Applicant: Julie Long; City of Bloomington
Consultant:
Project: Stream Channel Stabilization
Location: 7808 CreekrIDGE Circle: Bloomington
Rule(s): 2,5, 7 and 10
Reviewer: BCO

Permit #: 2018-129
Project Name: Streambank Stabilization – 7808 CreekrIDGE Circle: Bloomington
Approval Date: December 19, 2018

CITY OF BLOOMINGTON MINNESOTA
 ENGINEERING DIVISION
 PUBLIC WORKS DEPARTMENT
 2018-902 POND AND STORM SEWER MAINTENANCE PROJECT

BANK RESTORATION

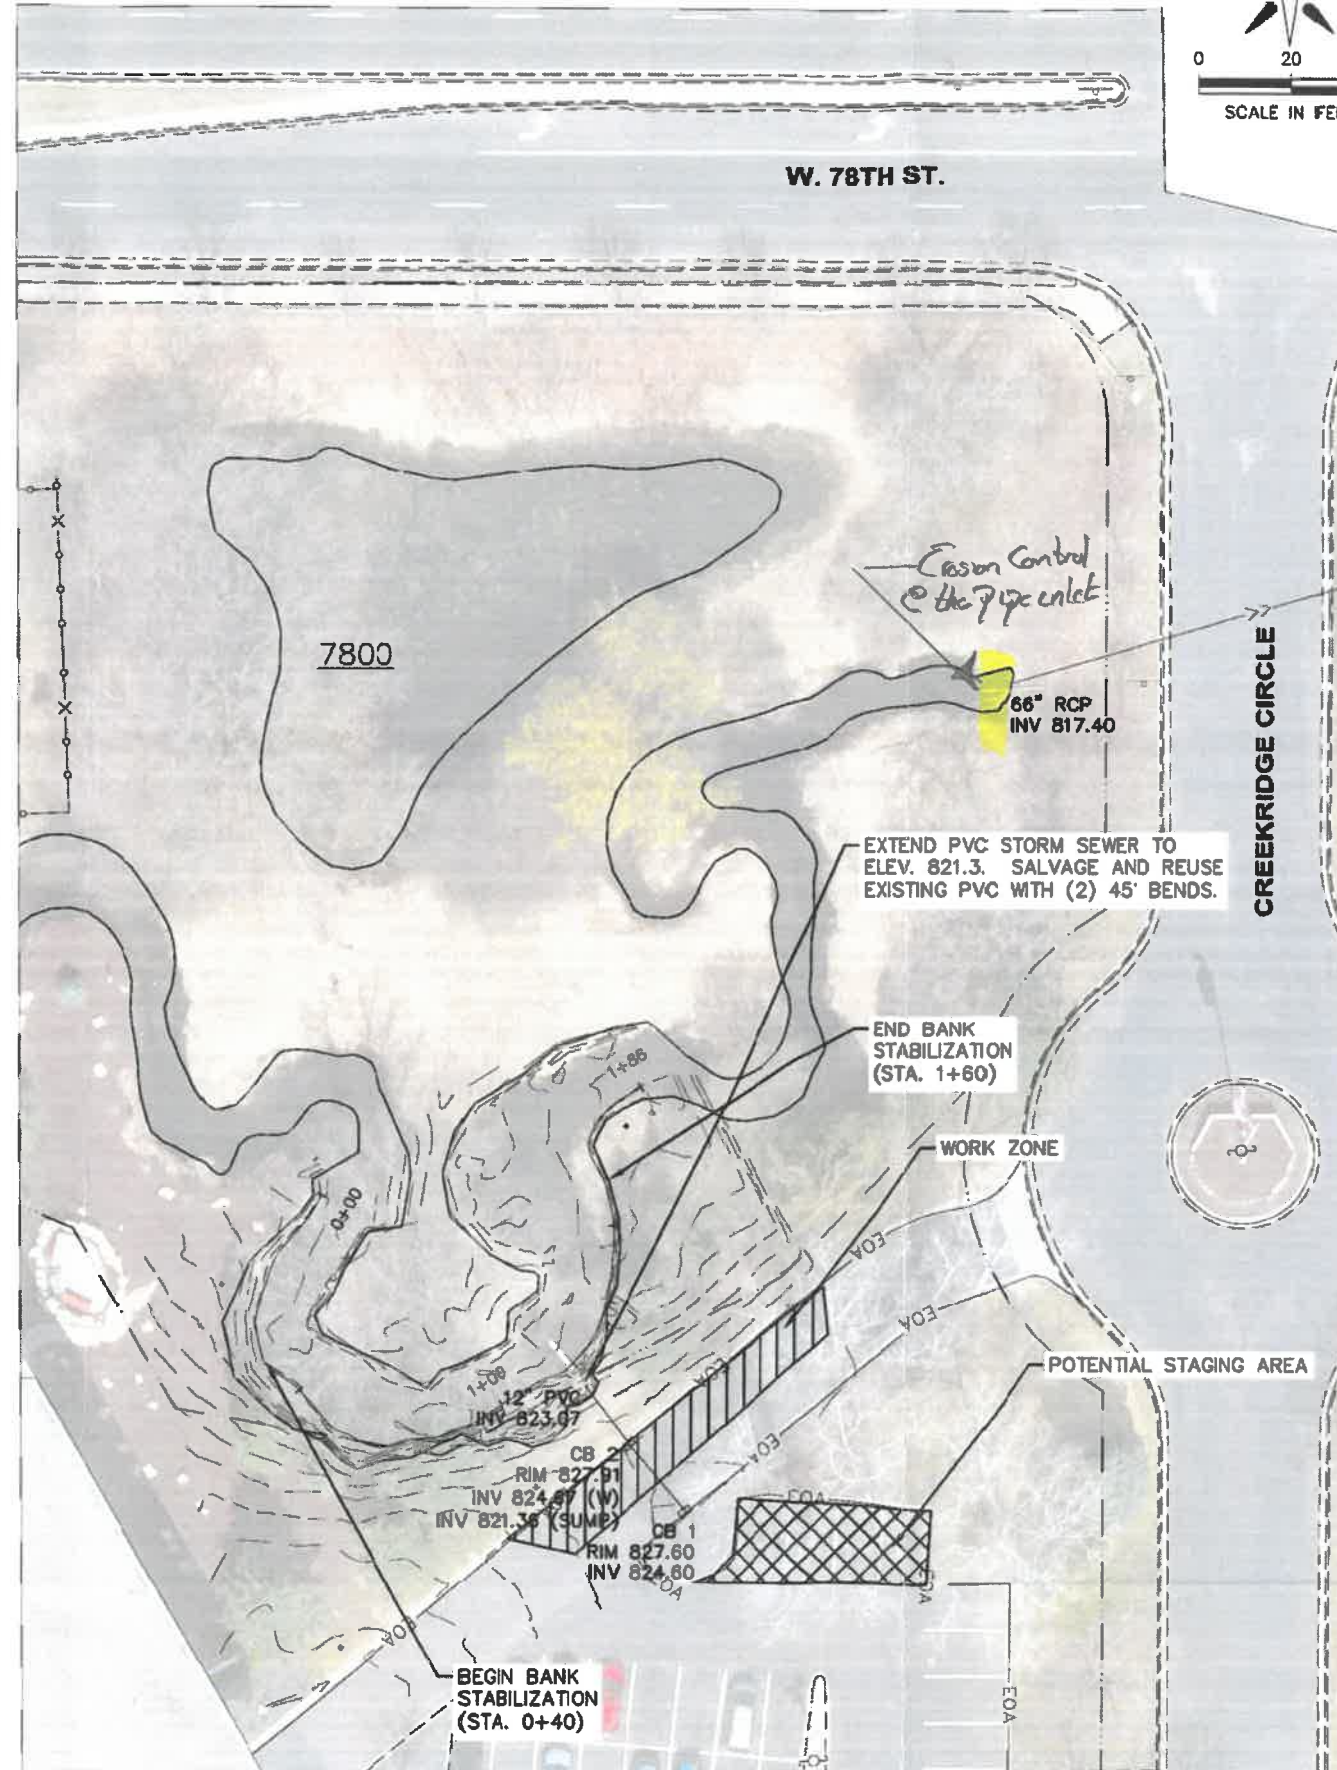
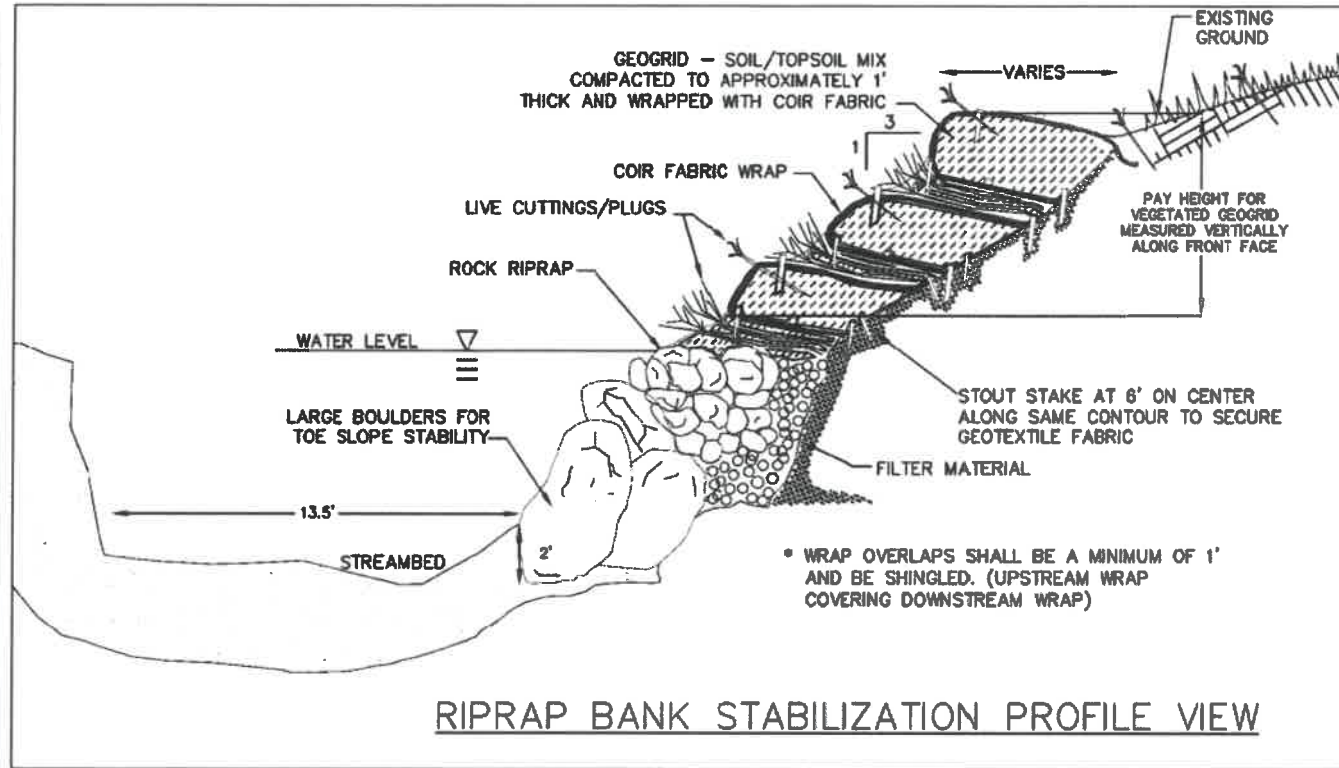
The project proposes the use of Class III field stone rip-rap, MnDot 2511 and 3601, having a maximum size of 18-inches, with 8-inches of granular filter material, MnDot 3601. The objective is to maintain the natural characteristics of the creek system yet provide for a stable slope that forms the creek bank.

Filter material used will be 8-inches in depth complying with MnDot 3601. In discussions with the City, they are reviewing their stabilization detail for incorporating geotextile filter fabric into the proposed stabilization design. The toe boulders are shown to be installed half buried below the normal level of the creek.

The thalweg of the creek in this area is approximately 817 M.S.L. The toe boulders and field stone rip-rap will extend to the elevation of the bank opposite the stabilization, approximately elevation 821 M.S.L. The 100-year flood elevation of the creek at this location is 825 M.S.L. Stabilization to the top of the creek bank complies with the rule. The bioengineering will continue approximately 8 to 10 feet above the creek level to the top of the eroded area. Areas that have not been subject to erosion will remain in its current condition.

The plans show the stabilized channel banks at a slope of 3:1.
